GOVERNMENT/INDUSTRY AERONAUTICAL CHARTING FORUM
Instrument Procedures Group
May 1, 2007
HISTORY RECORD

FAA Control # 07-01-275

Subject: Radar Required for Missed Approach

ILS RWY 35 WILMINGTON INTL (ILM)

WILMINGTON INTL (ILM) ILS RWY 35

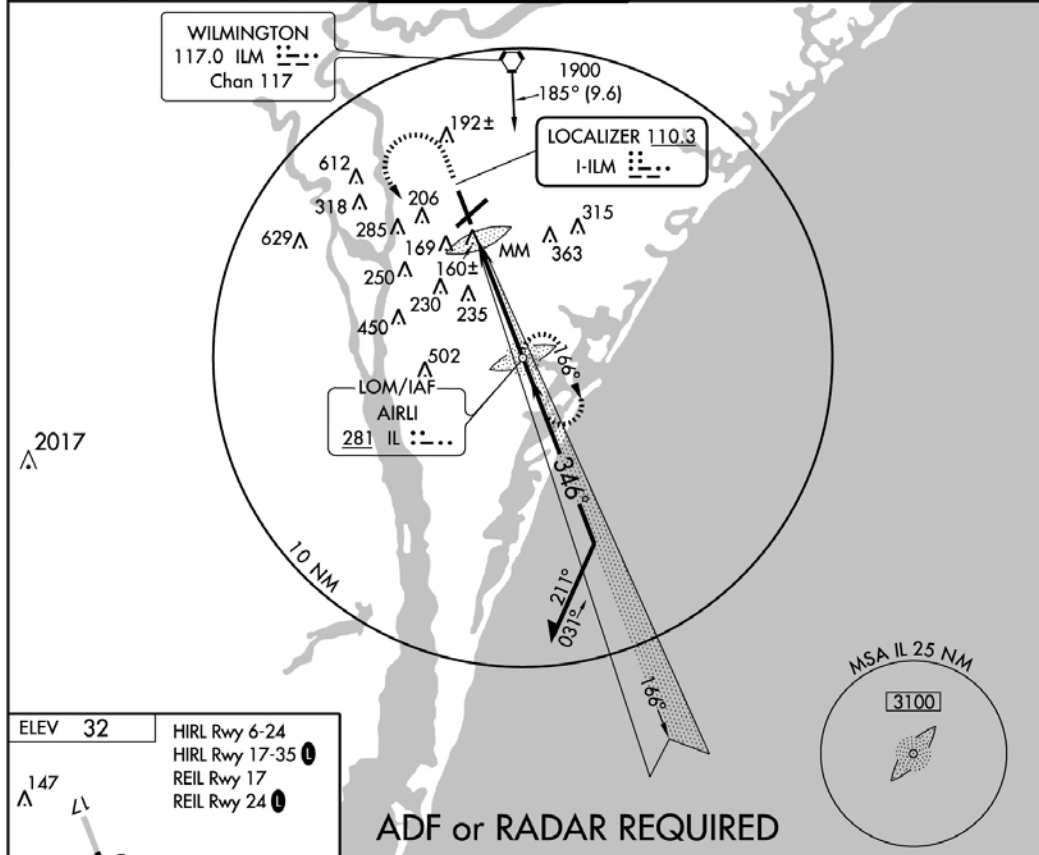
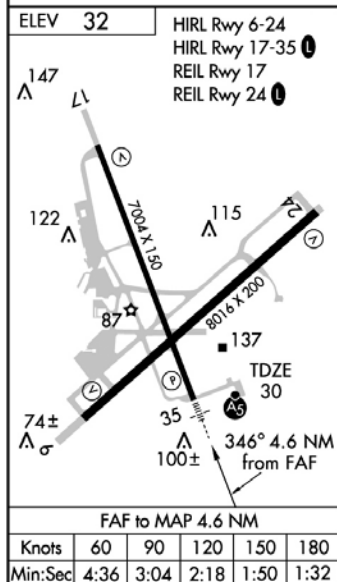
Background/Discussion: Attached is a copy of the NACO Chart for the Wilmington Int'l, NC (KILM) ILS RWY 35. The large procedural data note states, "RADAR or ADF REQUIRED." With a casual reading, based on the typical meaning of such notes, many pilots would conclude that either radar or ADF is required for procedure entry. In fact, either ADF or radar is required for the missed approach procedure. Thus, the aircraft without ADF equipment has to "bet on the come" so to speak, that ATC radar vector services will be available in the future event of a missed approach.

The group must carefully consider whether we want to accept radar-required missed approach procedures. This appears to be a recent shift in FAA policy. NBAA is of the impression that Part 121 flights, for example, cannot be dispatched to use a procedure that provides only radar vectors for the missed approach. NBAA requests that the FAA be prepared to confirm or refute this understanding at the meeting for the benefit of the group.

Recommendations: Historically, an IAP such as the example attached, would simply state "ADF Required." NBAA urges the group to recommend the FAA return to that more conservative, navaid-based policy.

Comments: NBAA is uncertain where this policy changed is authorized.

Initial Discussion Meeting 07-01: New Issue presented by Rich Boll, NBAA regarding the procedural data note “RADAR or ADF REQUIRED” on the Wilmington, NC (KILM) ILS RWY 35 approach. NBAA is concerned that many pilots will conclude that either radar or ADF is required for procedure entry. In fact, either ADF or radar is required for the missed approach procedure. Thus, the aircraft without ADF equipment has to “bet on the come” so to speak, that ATC radar vector services will be available in the future event of a missed approach. This appears to be a recent shift in FAA policy as NBAA is of the impression that Part 121 flights, for example, cannot be dispatched to use a procedure that provides only radar vectors for the missed approach. NBAA requests that the FAA be prepared to confirm or refute this understanding at the meeting for the benefit of the group. Historically, an IAP such as the example attached, would simply state “ADF Required.” NBAA urges the group to recommend the FAA return to that more conservative, NAVAID-based policy. Tom Schneider, AFS-420, responded that the plan view note on the approach in question is not in accordance with current guidance in Order 8260.19. There is a terminal route from the en route structure to the IAF. However, the LOM is required for procedure entry and the course reversal maneuver, therefore, a planview note “ADF REQUIRED” is required under Order 8260.19, paragraph 855h(1). ADF or radar is also required for the missed approach; therefore a second equipment note “ADF or RADAR REQUIRED” is required for the briefing strip under paragraph 855h(2). A “RADAR REQUIRED” note in the plan view is only required when radar is the only method for procedure entry from the en route environment under paragraph 855g(2). Brad Rush, AJW-321, took the IOU to amend the procedure.

MEETING 07-02: Brad Rush, AJW-321, briefed that a P-NOTAM amending the “ADF or RADAR REQUIRED” note on the Wilmington, NC ILS RWY 35 IAP has been issued. He recommended the issue be closed. Rich Boll, NBAA, concurred. [Item Closed](#).
